## **CEC Committee Workshop on the Combined Heat and Power Guidelines (AB1613)**

October 12, 2009

## **PG&E largely supports the CEC's draft recommendations and proposes changes to help ensure GHG emission reductions**

**PG&E's Proposed Carbon-Neutral Double-Benchmark  
as Function of Power-to-Heat Ratio**

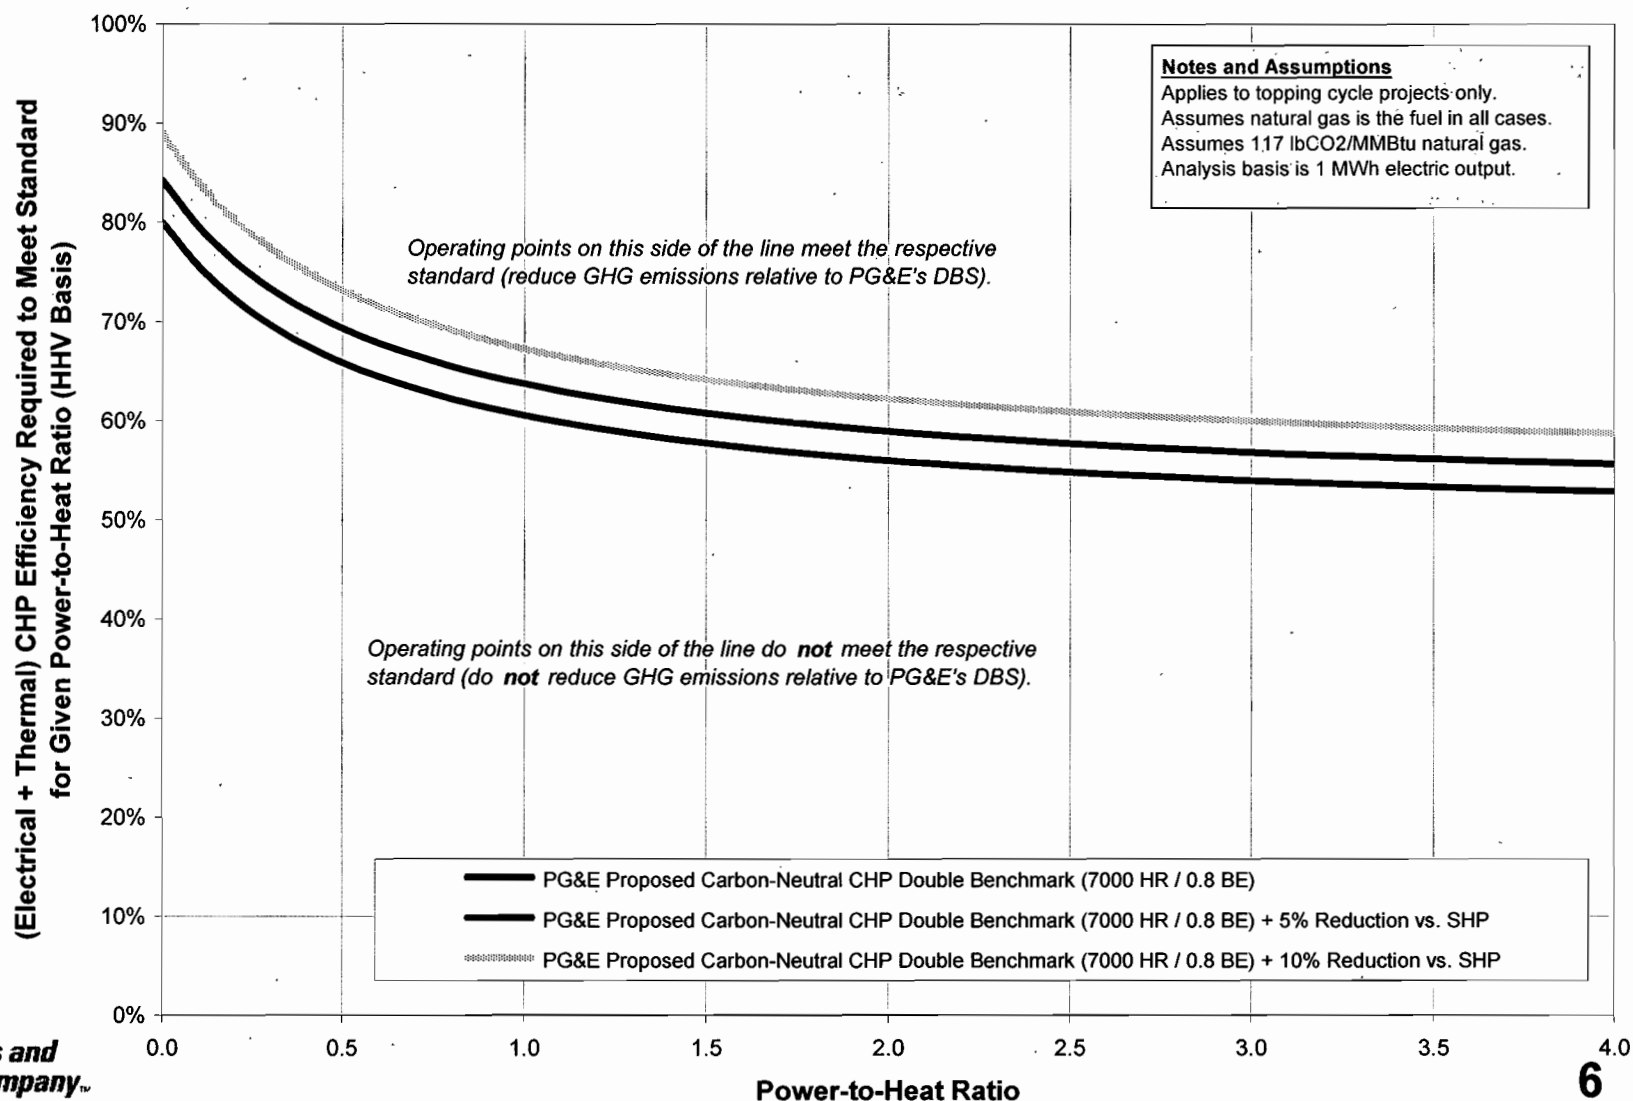
# The Double Benchmark Standard is the appropriate measure for GHG emissions

## The CEC efficiency standard can be simplified

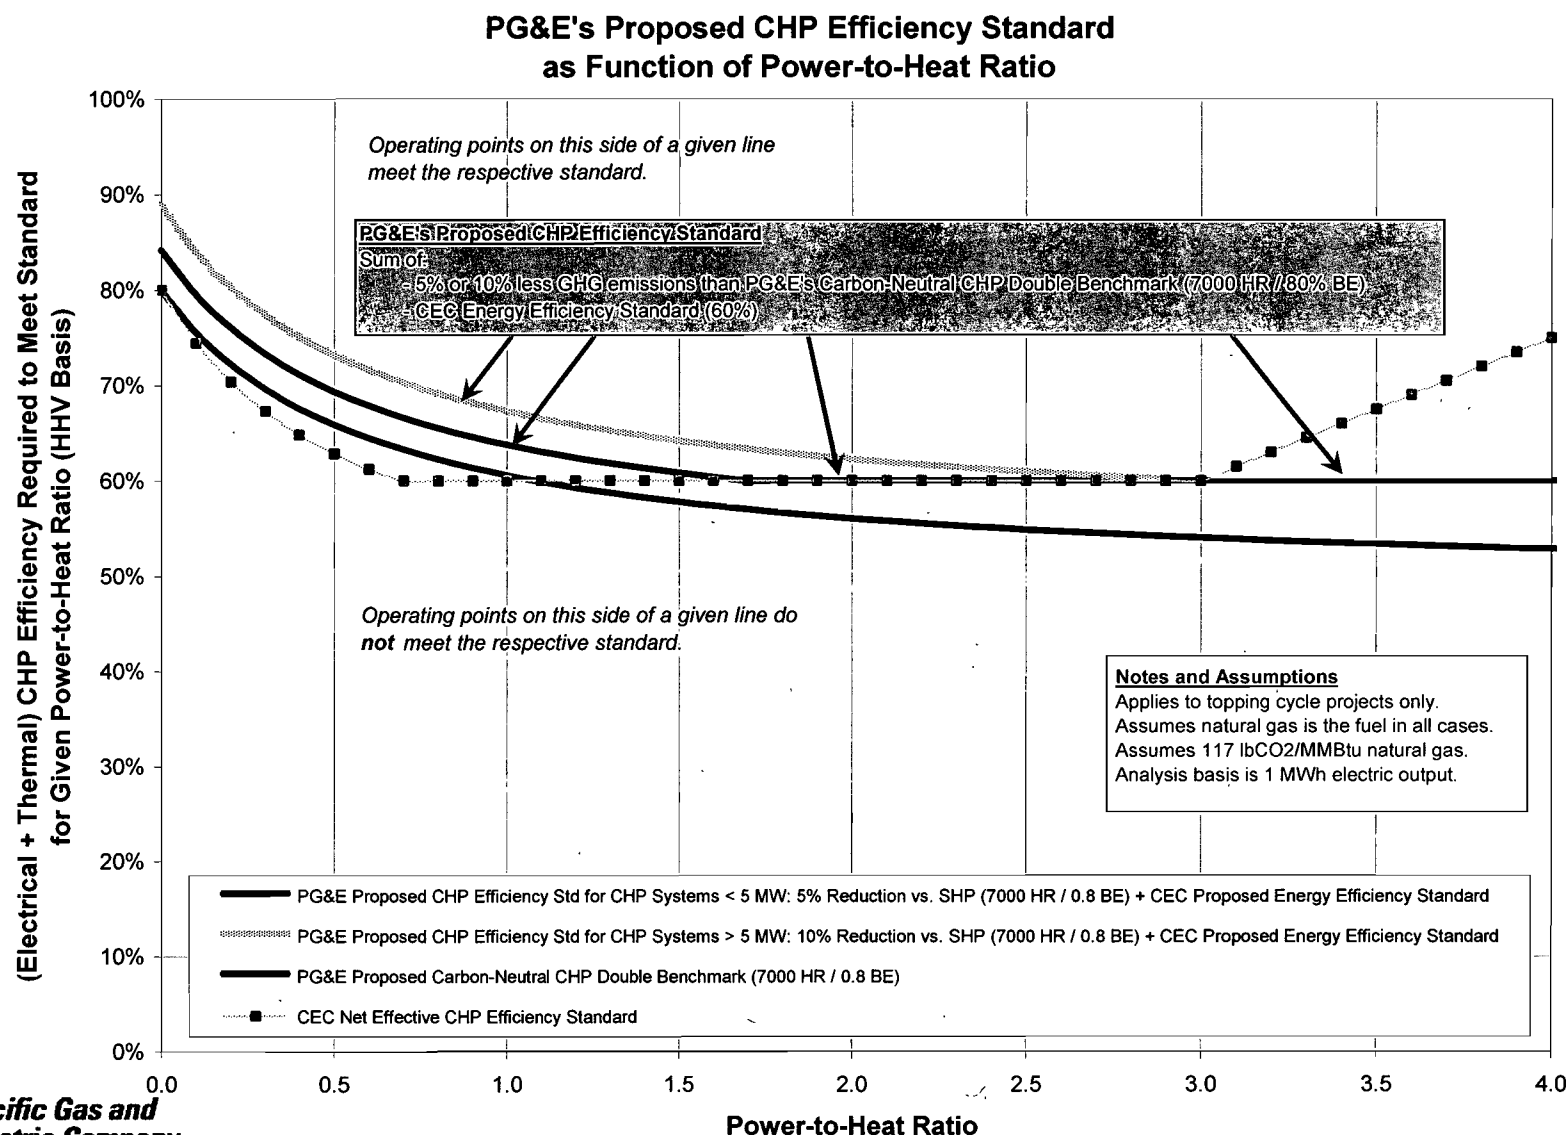
- PG&E proposes use of the Double Benchmark Standard with the 60% total efficiency requirement
  - The latter is required by statute (PUC § 2843(e))
- GHG emissions standard can be dropped because it is at all times a lower standard than the Double Benchmark
- The Fuel Savings Standard can be dropped because it is not more efficient than an appropriate Double Benchmark
- Thermal requirement can be dropped because it is less than the Double Benchmark plus 60% except in cases where electric generator is so high as to be unrealistic in today's market
  - The 60% requirement ensures that thermal match will occur, which is the statutory requirement
